HURRICANE CITY UTAH

Hurricane Planning Commission Meeting Agenda

March 28, 2024
5:00 PM

SHEET
C2
OF 12

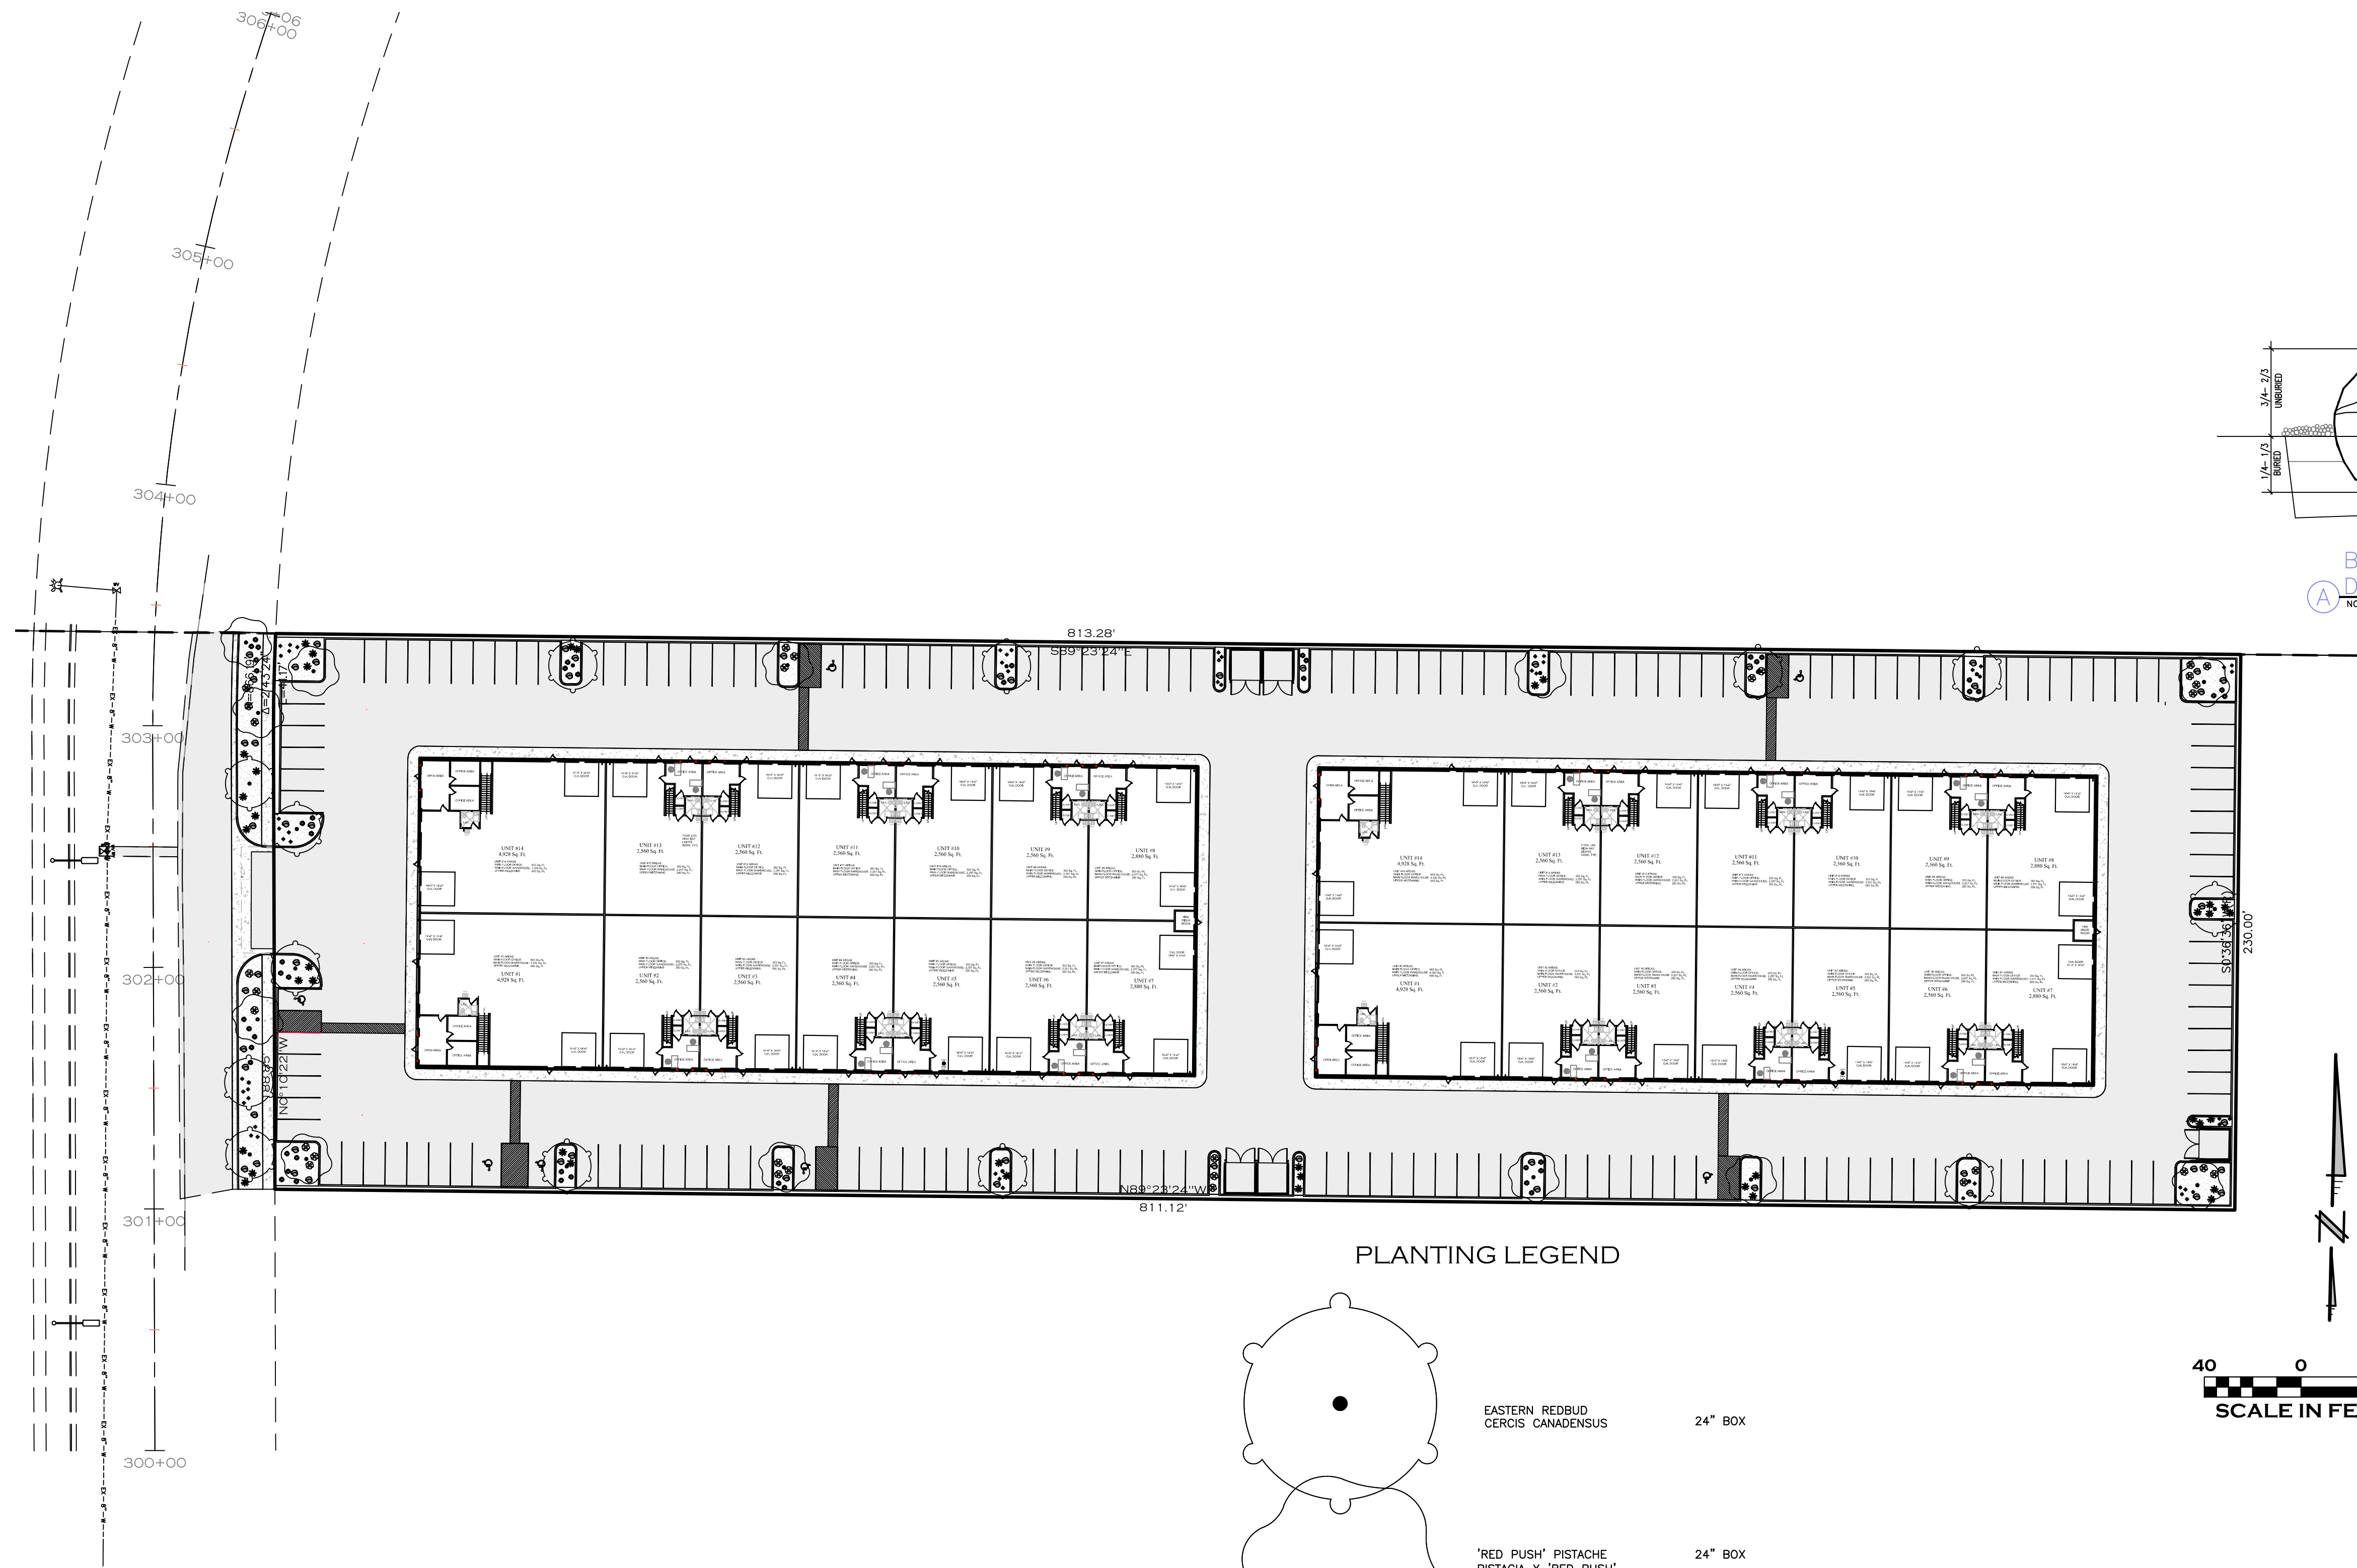
1. The layout, setbacks, and sizes comply with M-1 zoning standards.
2. **Landscaping:** A landscaping plan has been provided. The plan shows one tree and three shrubs for every 35' of frontage as required by code as well as appropriate parking lot landscaping.
3. **Outdoor Lighting:** No outdoor lighting has been proposed. Any and all outdoor lighting will need to meet HCC 10-33-7.
4. **Parking:** Per their calculations, 174 spaces including 7 ADA stalls are provided and 100 spaces are required.
5. The applicant has provided building renderings as required. The buildings are under 60' in height. The property is zoned M-1, light industrial, thus no conditional use permit is needed for metal buildings.

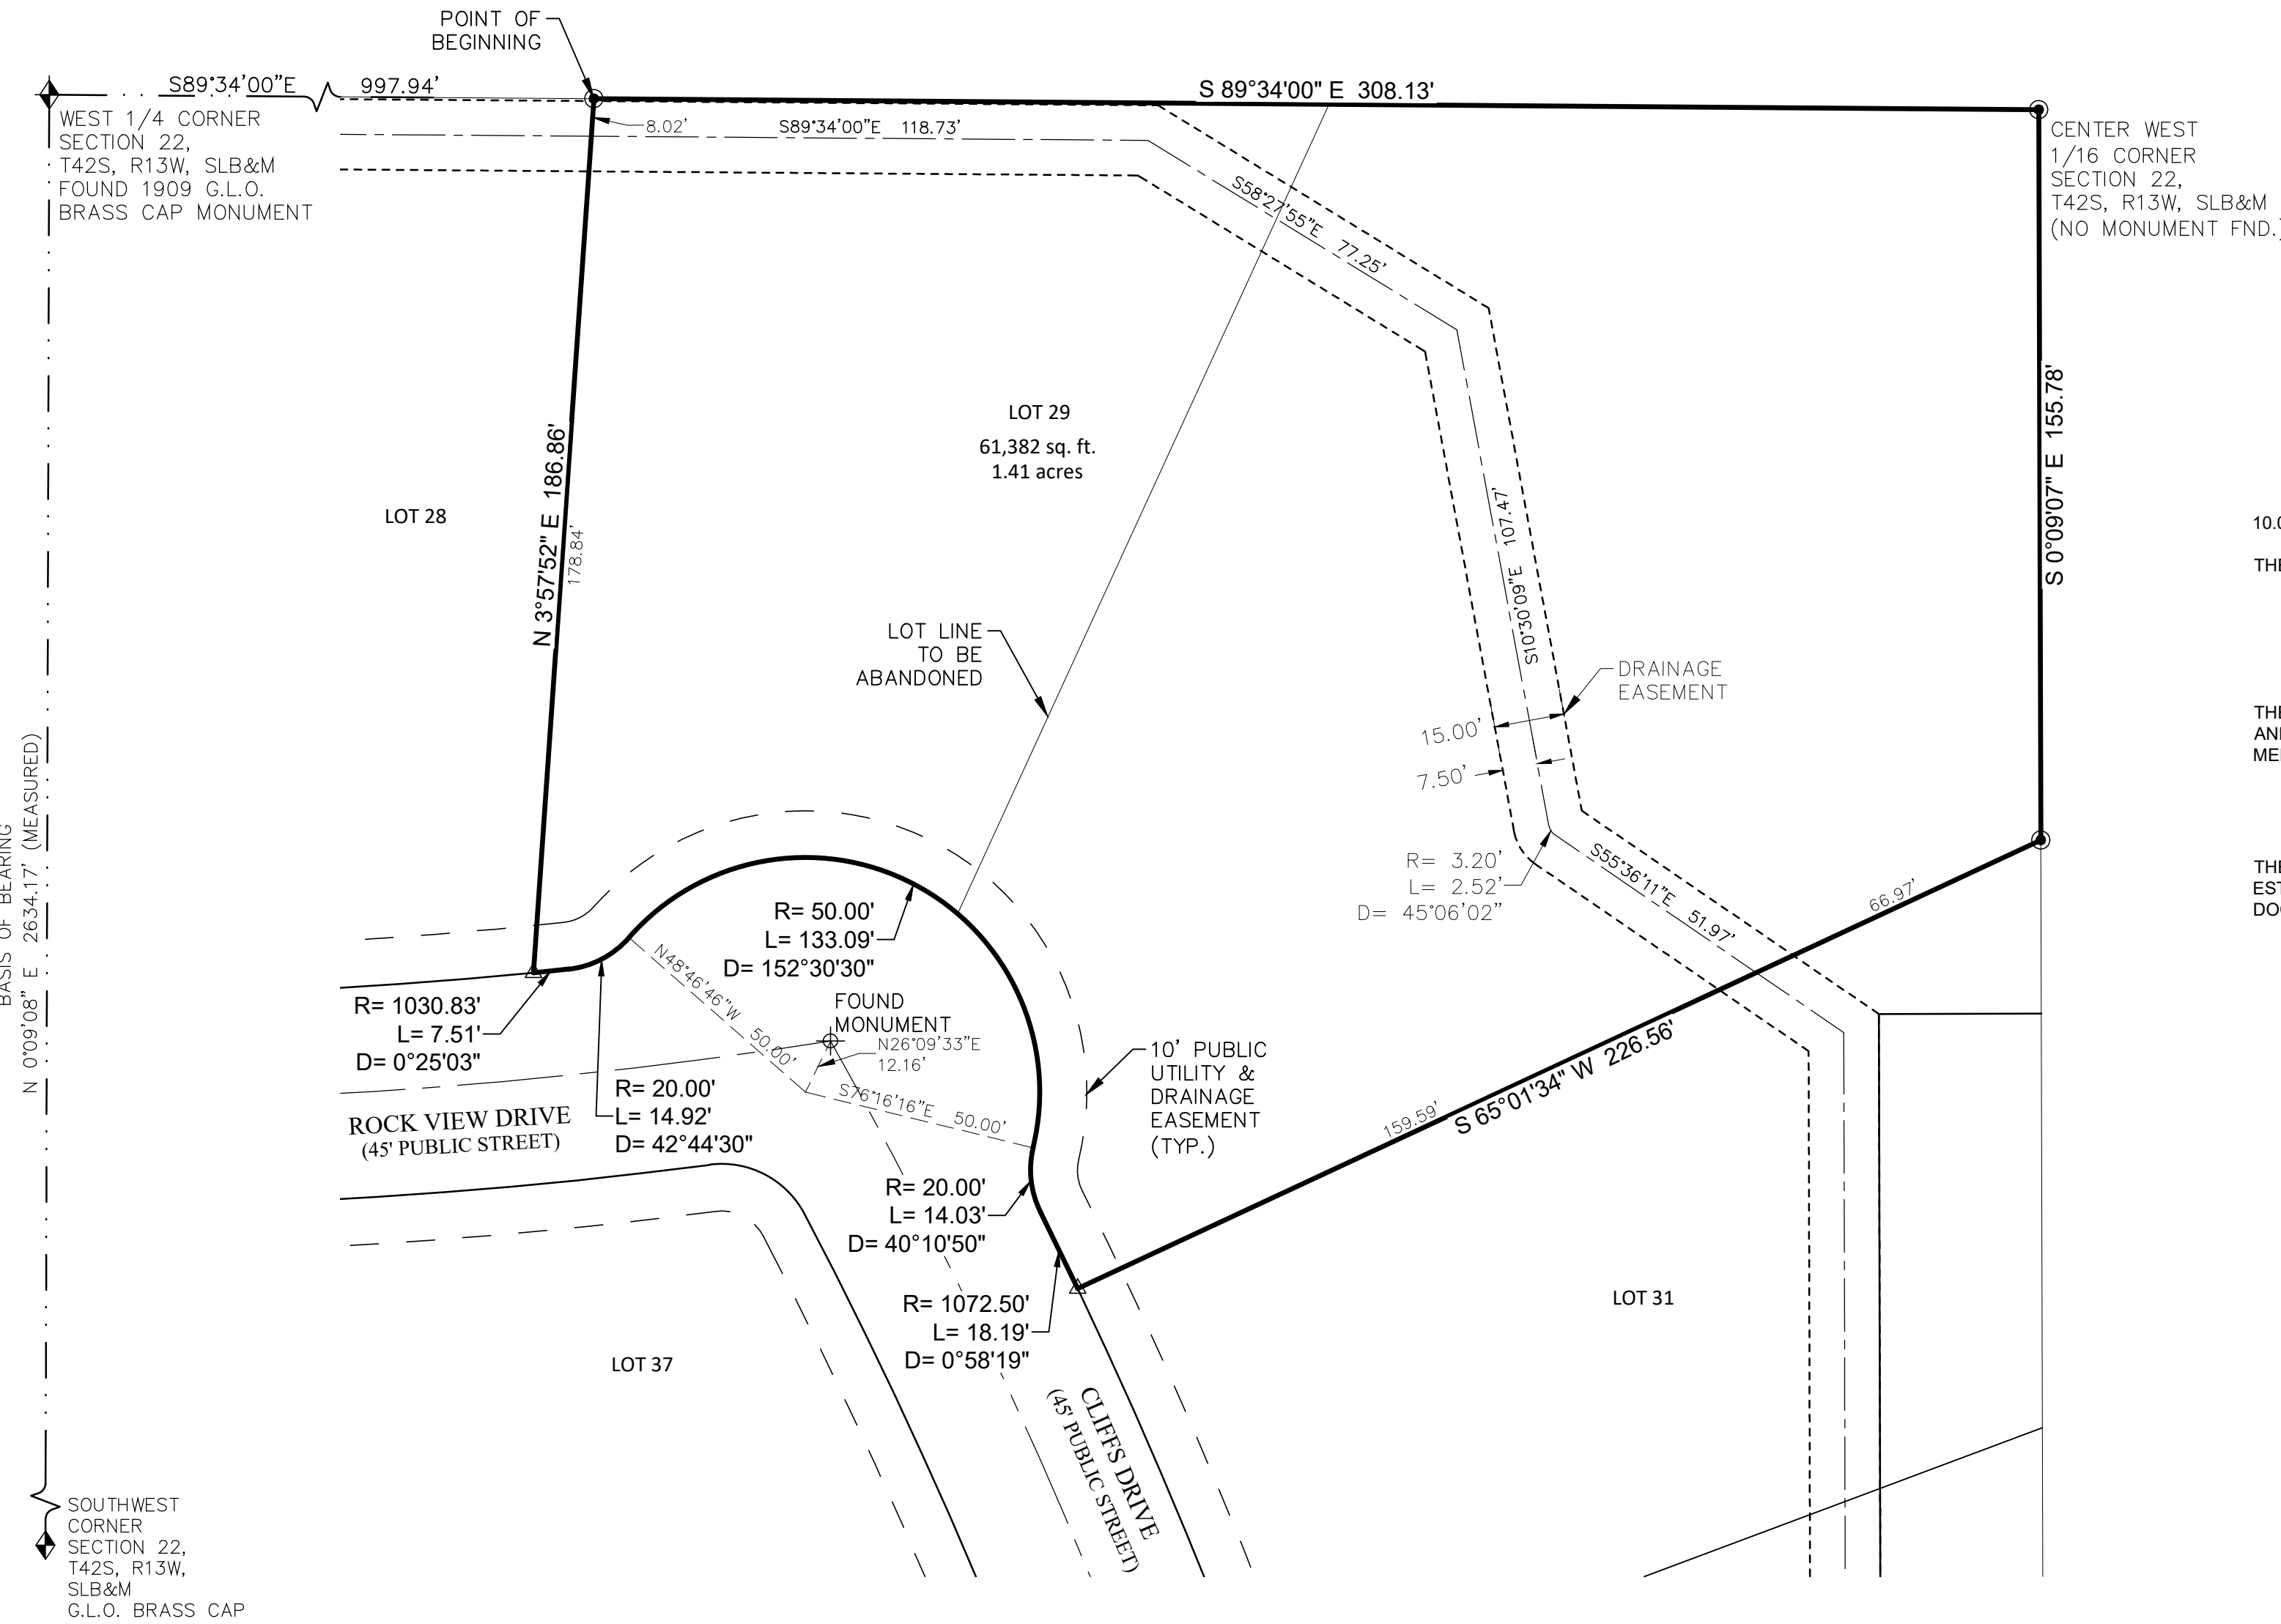
1. **Public Works:** Extra services to the new lot will need to be abandoned.
2. **Engineering:**
3. **Streets:**
4. **Water:**
5. **WCWCD:**
6. **Cable:**
7. **Fire:**
8. **Sewer:**
9. **Power:** Power will need to be removed; secondary box and streetlight pole have to be relocated to new lot line (Hurricane Power Standards, drawings DR-20, 21, 22, section 2 bullet 6, section 3 - pg 8 - unit 3A). Water meter will have to be fed from the south lot line, and the existing water meter on the northwest lot line removed (Hurricane Underground Standards, section 3 table 2).

2. The Final Plat needs a full review by the City Engineering Department for surveying details.
3. Additional services need to be abandoned to the additional lot.

LANDSCAPE PLAN FOR:
BENCH LAKE TOWNHOMES PHASE 1-3
HURRICANE, UTAH 84731
LOCATED IN SECTION 21, T42S, R13W, S.L.B.&M.

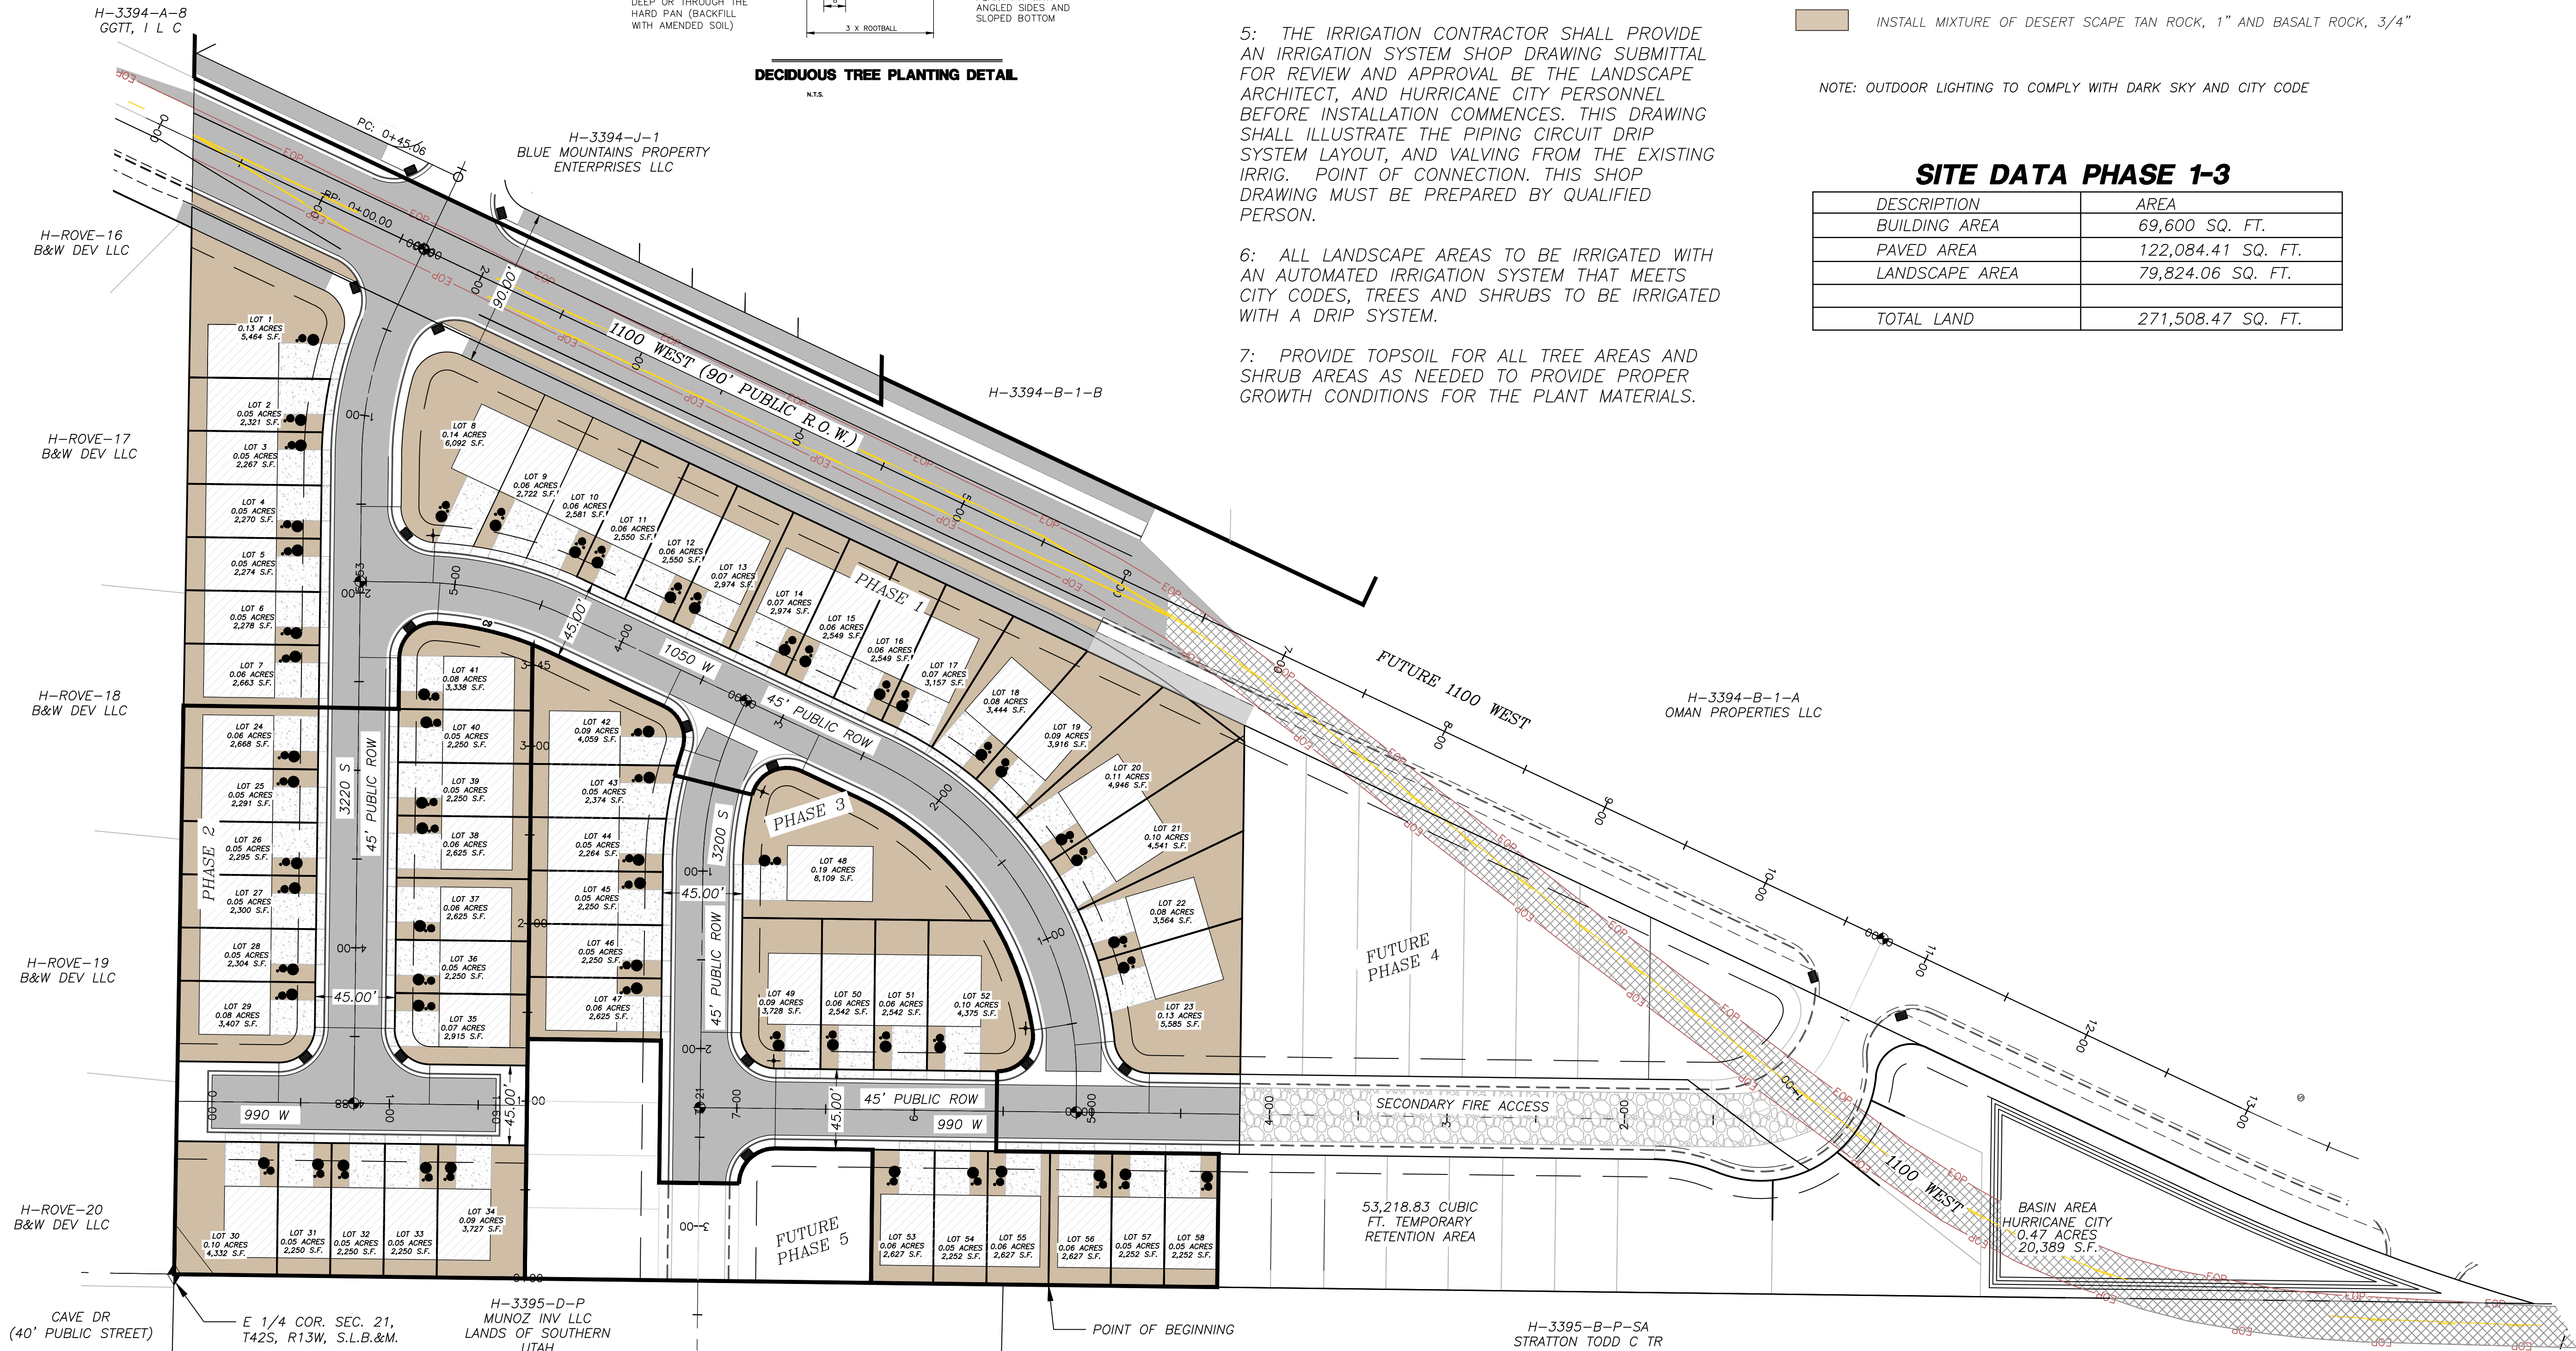
- a. Each unit will have a two car garage and sufficient driveway space to meet this code.
- 4. Adjoining properties and uses should be shown on the site plan.
- 5. A note has been added to the plans that all outdoor lighting will comply with HCC 10-33-7.
- 6. A landscaping plan has been provided that does meet Hurricane City Code including one tree and two shrubs per unit.
- 7. Per HCC 10-33-5 and 10-37-9 a wall of fence should be installed around the exterior of the project. Some retaining walls are shown on the plans, additional buffering for residences backing up 1100 W should be considered.
- 8. Building elevations have been provided. All units will be two story units under 35' tall.
